Subject: Lodi Energy Center (08-AFC-10)
Supplement D -Changes to Equipment and Project Fenceline

Application for Certification

Supplement D
Changes to Equipment and Project Fenceline

California Energy Commission

FIGURE 1.1-1R
ARCHITECTURAL RENDERING
LODI ENERGY CENTER
LODI, CALIFORNIA

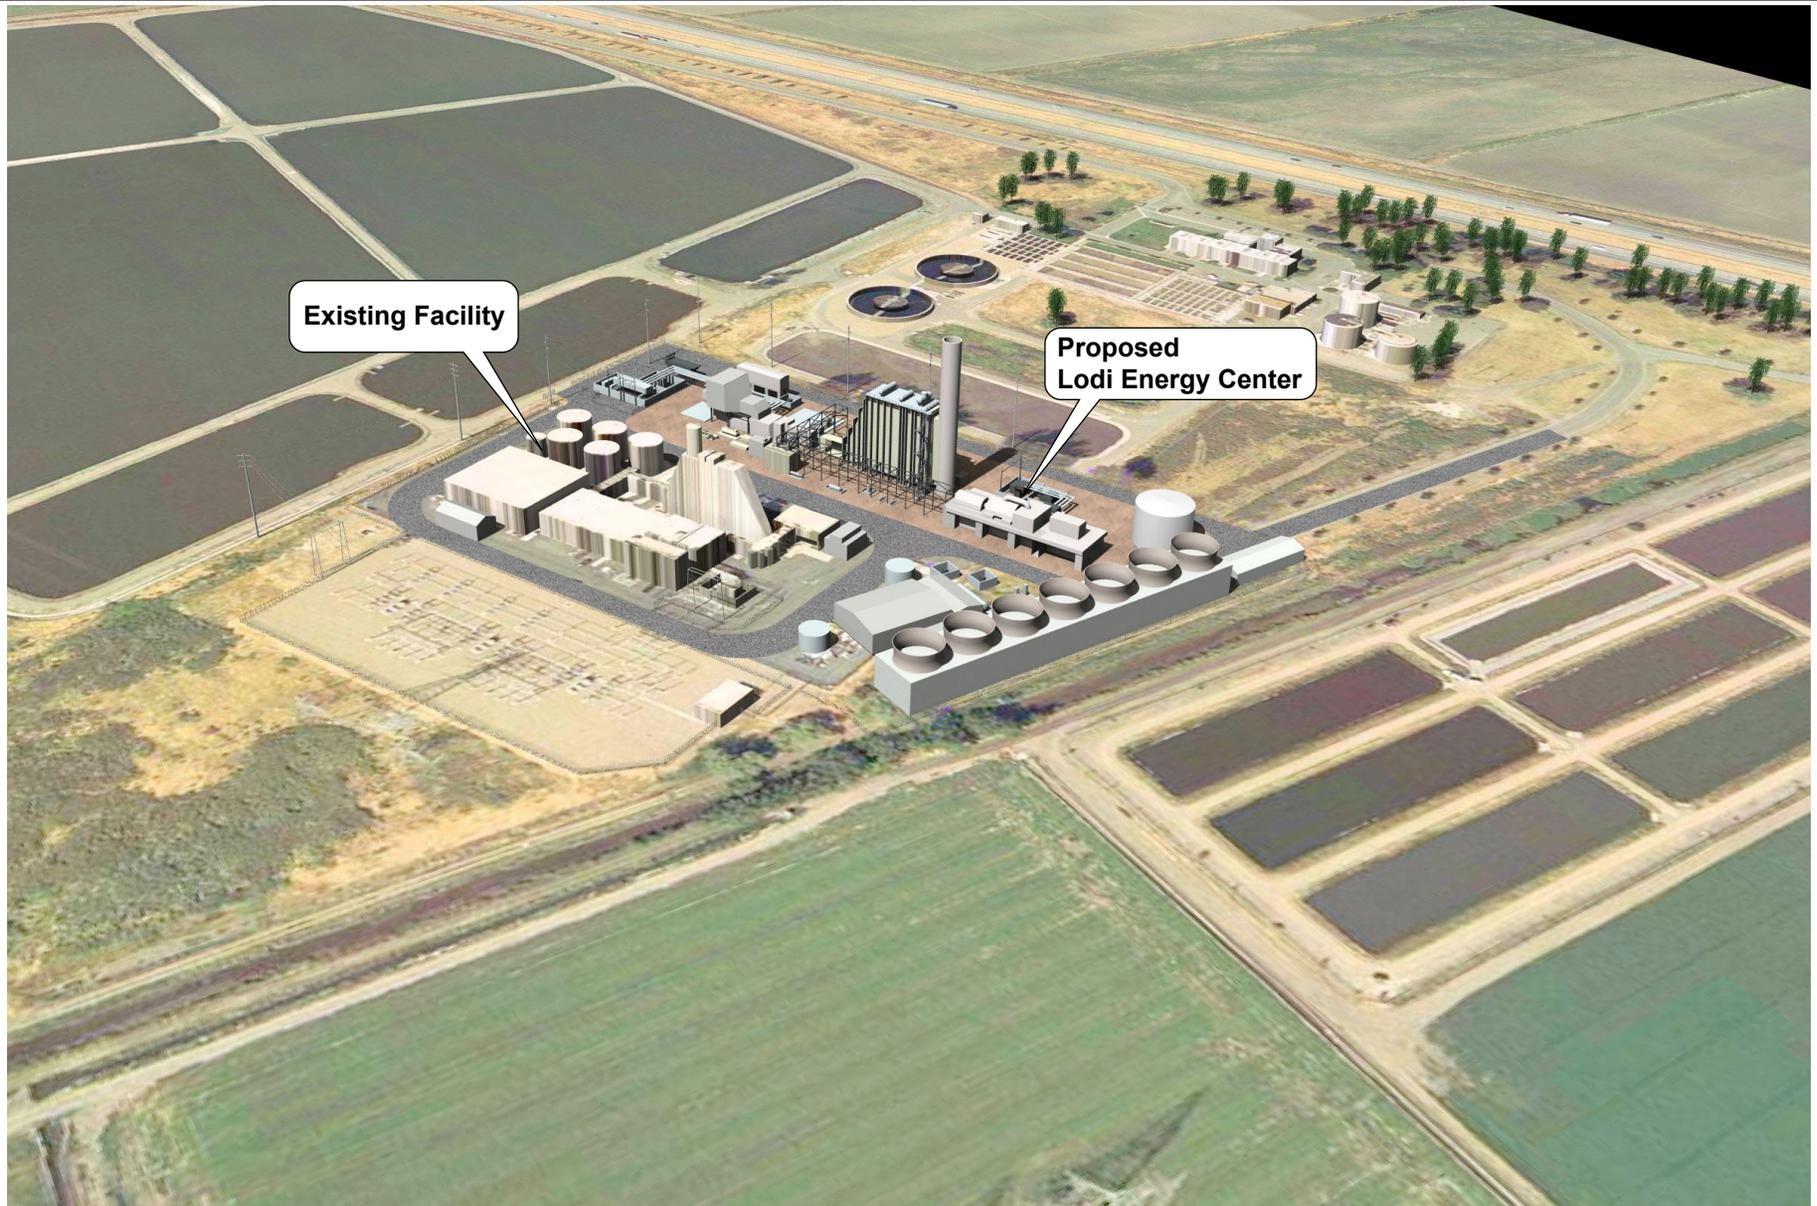
Modification	Reason for Change
Figures	
Figure 1.1-1R, Oblique Rendering	Equipment changes resulted in minor changes to the plant simulations. Equipment changes are only visible in the Oblique Rendering, KOP-1 and from KOP-2.
Figure 2.1-1R, General Arrangement	The Siemens equipment is different in type and size from the originally proposed GE equipment.
Figure 2.1-2R, Elevation Drawings	The elevation drawings have been revised to reflect the changes to the General Arrangement.
Figure 2.1-4AR, Heat Balance	The change to Siemens equipment resulted in a modification to the heat balance.
Figure 2.1-4BR, Heat Balance Table	The change to Siemens equipment resulted in a modification to the heat balance.
Figure 2.1-5AR, Water Balance – Annual Average	The water balance changed due to an increase in process water throughput required by the Siemens equipment.
Figure 2.1-5BR, Water Balance – Summer Peak	The water balance changed due to an increase in process water throughput required by the Siemens equipment.

As a result of the additional transmission poles, the minor equipment changes, and fenceline modification, a revised architectural rendering has been provided as Figure 1.1-1R. Also, as a result of these revisions, key observation points (KOP) 1 and KOP-2 have had minor changes and updated simulations are provided as Figures 5.13-2R and 5.13-3R. The remaining KOP figures provided in the AFC remain unchanged due to the distance from the location of photo to the proposed power plant site. Although the new poles are taller than some of the structures at the proposed plant, they are not the tallest equipment onsite. Additionally, the poles are shorter than the surrounding transmission line corridors adjacent to the project, and are appropriate for the industrial nature of the area. Given the existing visual character of the site, project impacts associated with the equipment change are limited and considered less than significant.

FIGURE 2.1-1R
GENERAL ARRANGEMENT
 LODI ENERGY CENTER - SUPPLEMENT D
 LODI, CALIFORNIA

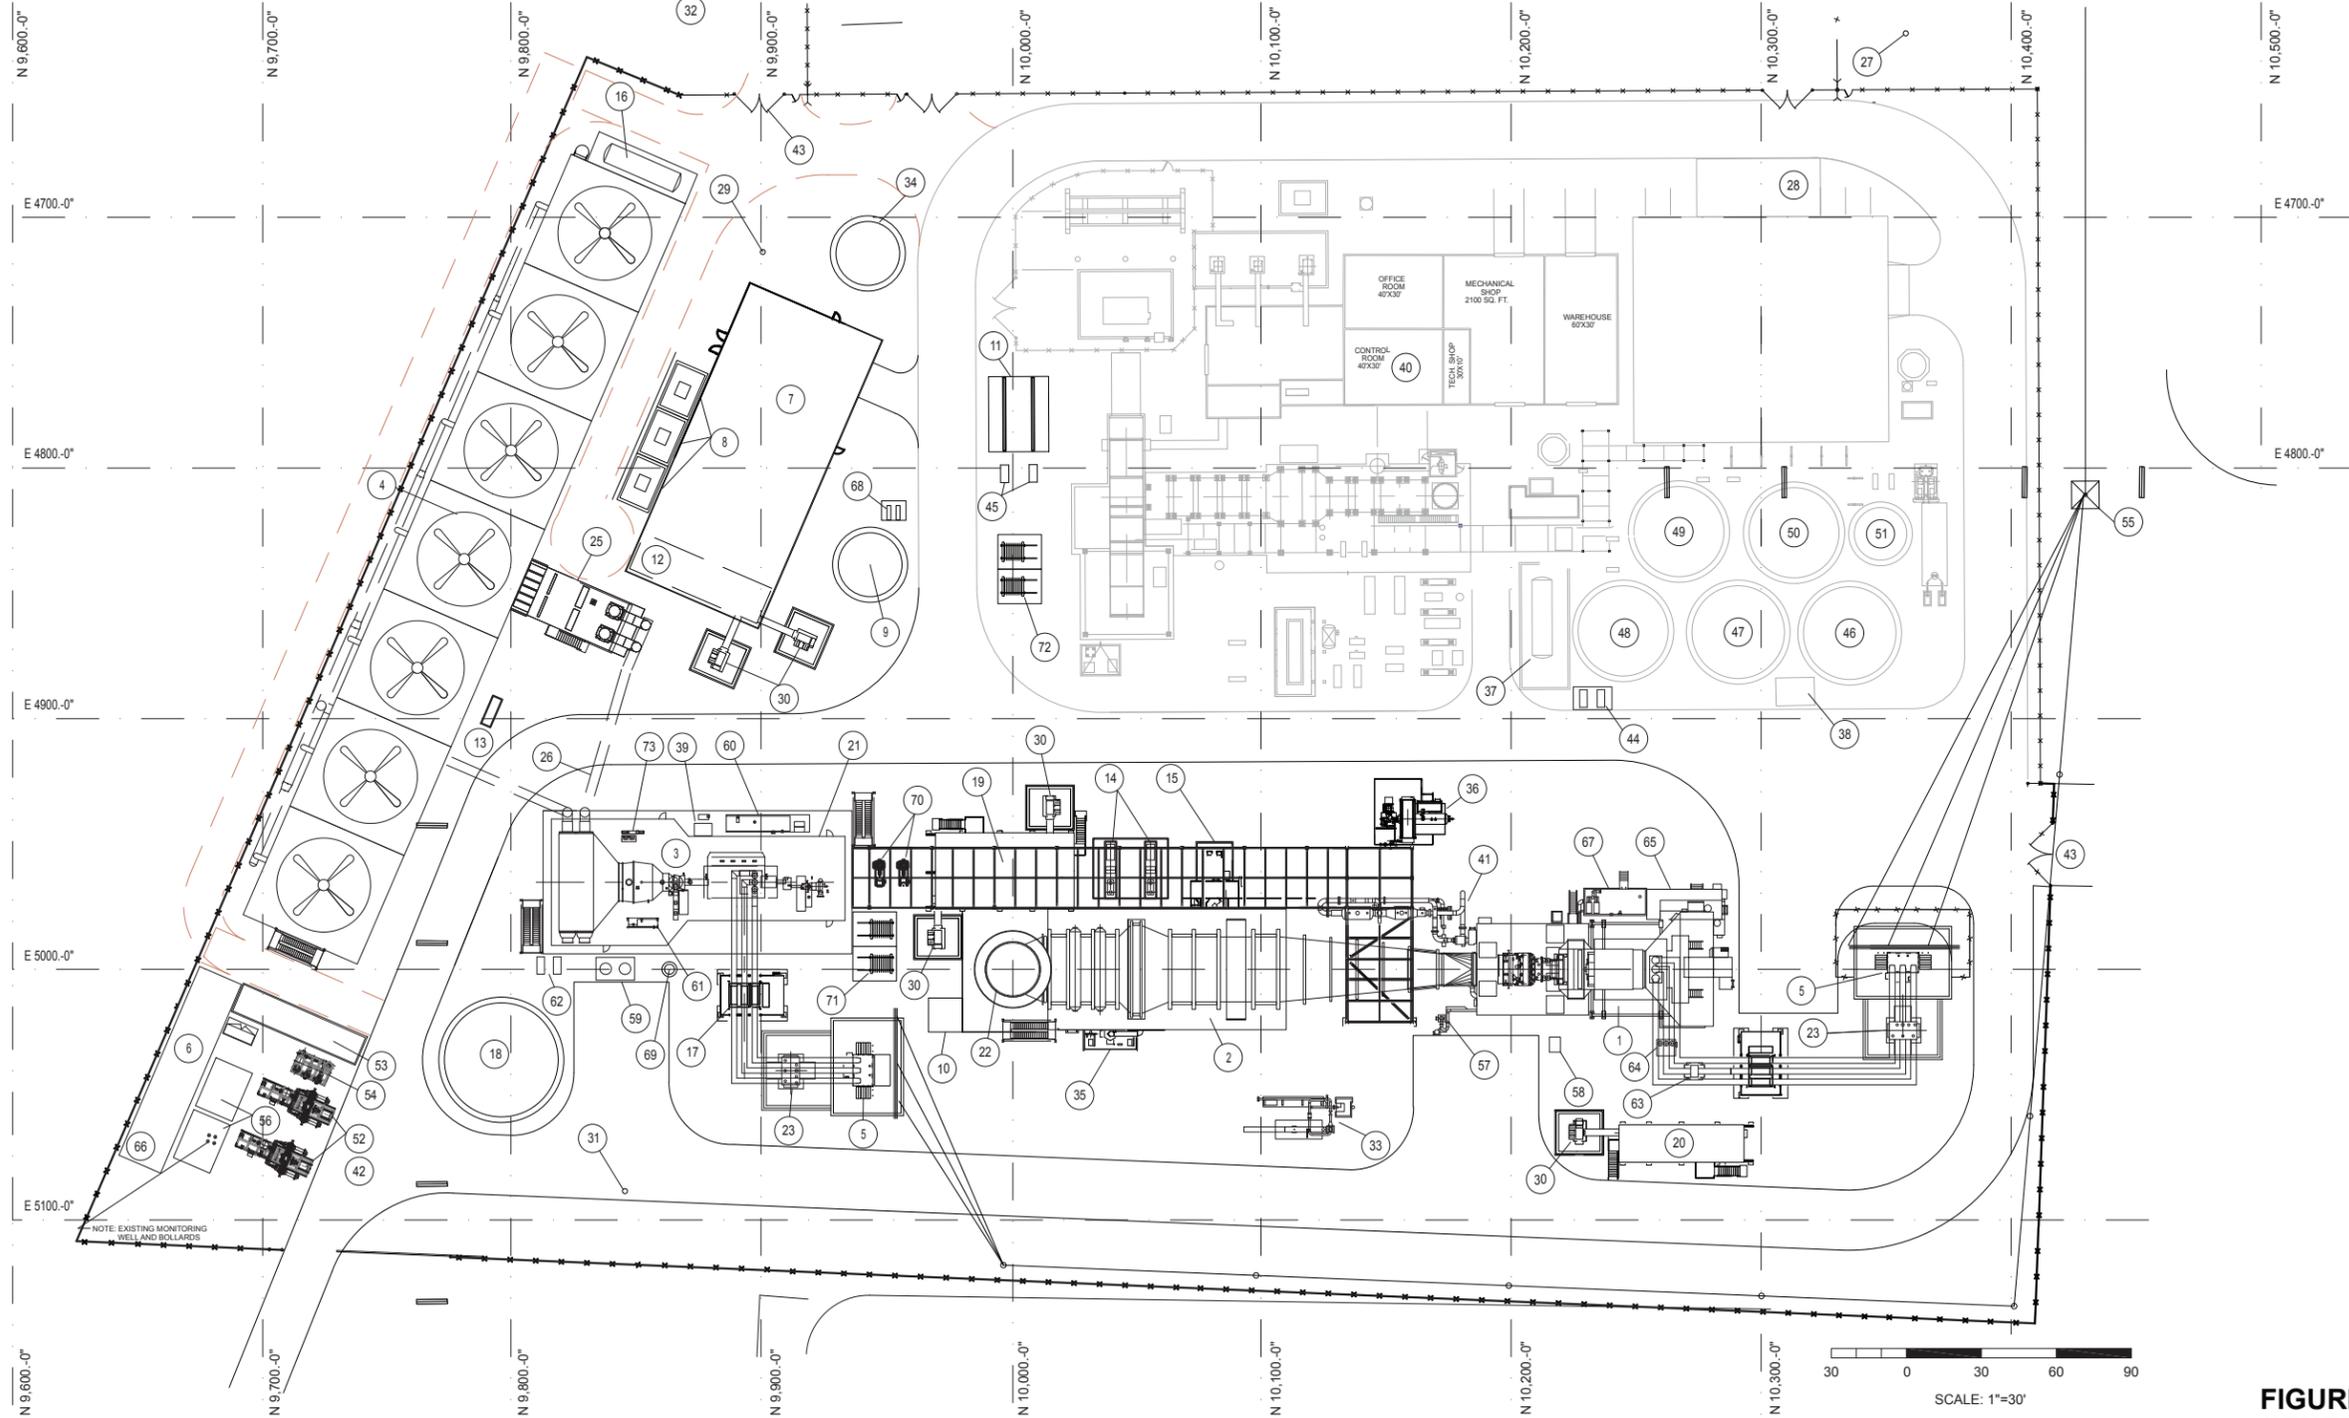
The Applicant is proposing changes to the power generation equipment and project fenceline at the LEC, as shown in Figures 2.1-1R and 2.1-2R. In lieu of the “Rapid Response” GE Energy Frame 7FA proposed in the AFC, NCPA has selected a combined-cycle nominal 296-megawatt (MW)¹ Flex Plant 30 power generation facility consisting of a Siemens STG6-5000F natural gas-fired CTG and a Siemens SST-900RH single condensing steam turbine. Due to the inherent design of the Siemens equipment, the heat recovery steam generator (HSRG) will no longer require supplemental firing. Additional project changes that result from the generating equipment changes are: (1) a reduction in the size of the auxiliary boiler; (2) a redesign of the plant cooling system, with resulting increases in the cooling tower water flow rate and maximum cooling water total dissolved solids (TDS); and (3) a change from a conventional triple pressure boiler that uses a high-pressure (HP) drum to a “Benson”-type triple-pressure boiler that utilizes a once-through HP section with no HP drum.

Moved eastern boundary of project site 30 feet east	City of Lodi requires a continuous fire loop road around the LEC. By moving the road 30 feet to the east, additional space is obtained to make installation of the loop road possible.
Realigned southern boundary of plant slightly north	SJCOG requirement for a 30 foot buffer from the irrigation canal to the southern fenceline of the plant.

FIGURE 2.1-5AR
WATER BALANCE DIAGRAM,
ANNUAL AVERAGE OPERATIONS
 LODI ENERGY CENTER - SUPPLEMENT D
 LODI, CALIFORNIA

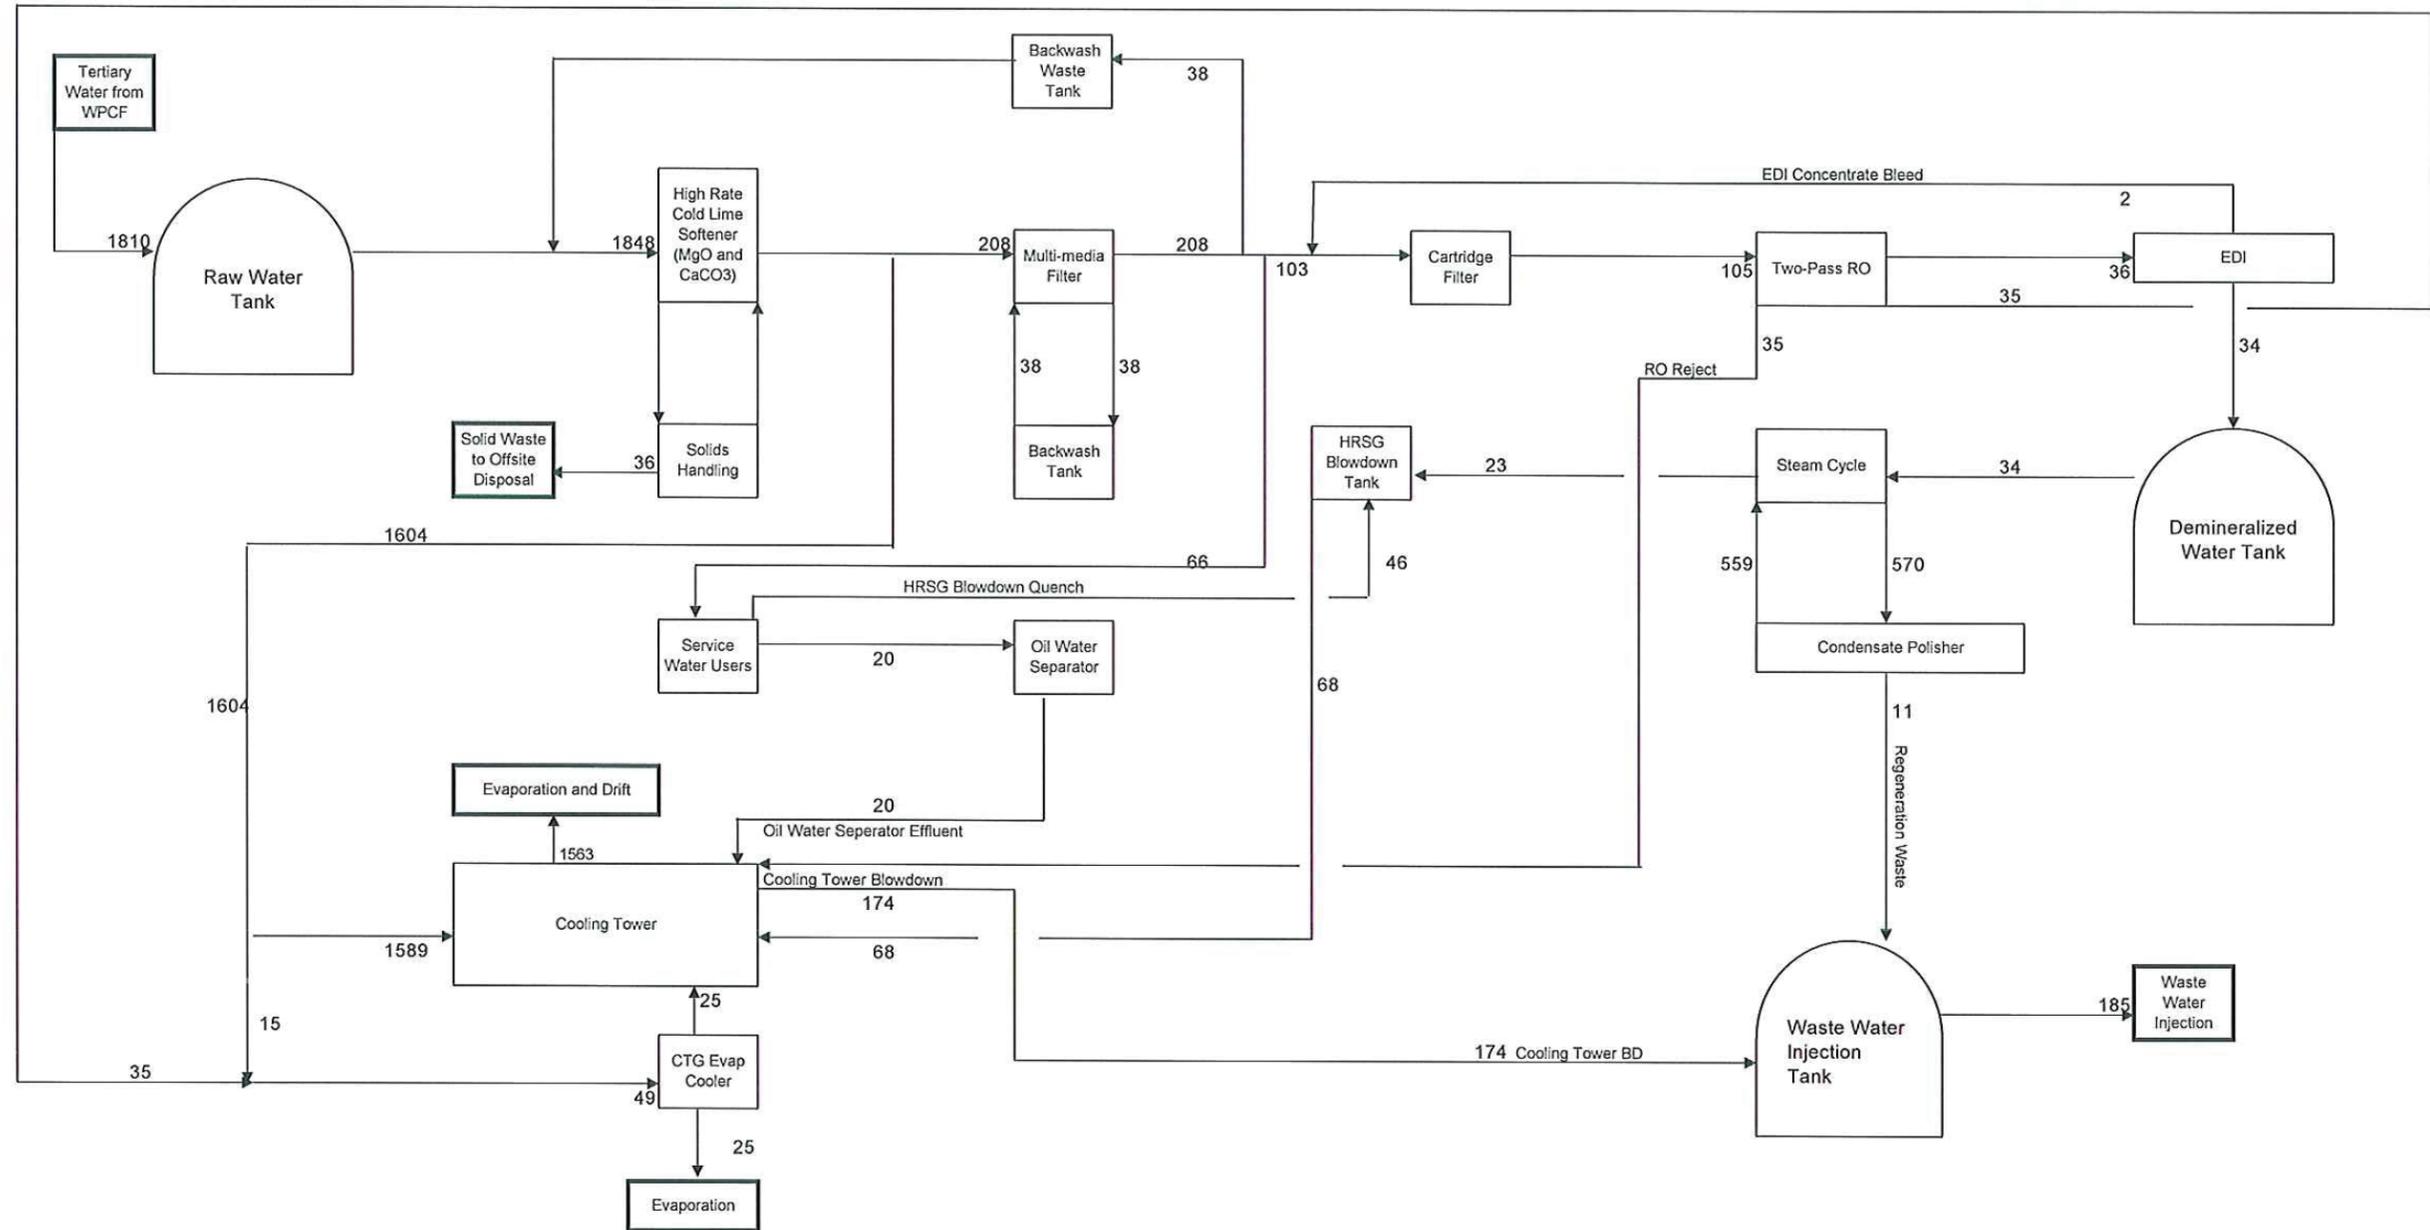
per the will-serve letter included as Appendix F. Therefore, the changes to the power generation equipment and the resulting increase in water use at the LEC will not change the impact analysis as presented in the AFC. A description of process water use and wastewater generation for the revised water balance (Figure 2.1-5AR) is presented below.

Figure 2.1-5AR shows the revised water balance for the LEC project. The demineralization system would include first and second pass reverse osmosis (RO) and electro-deionization. As shown in Table 3.15-1, the LEC's average daily water use would be approximately 1.84 million gallons per day (24-hour period). Maximum daily use would be 2.61 million gallons per day during the summer maximum case. A will-serve letter from the City of Lodi indicating that a sufficient amount of recycled water will be available to the project is included in Appendix F. Based on a 70 to 80 percent capacity factor (approximately 7,000 hours of operation per year), the LEC would use an average of 1,651 acre-feet (538.02 million gallons) per year of water using the average annual flow rate from Table 3.15-1.
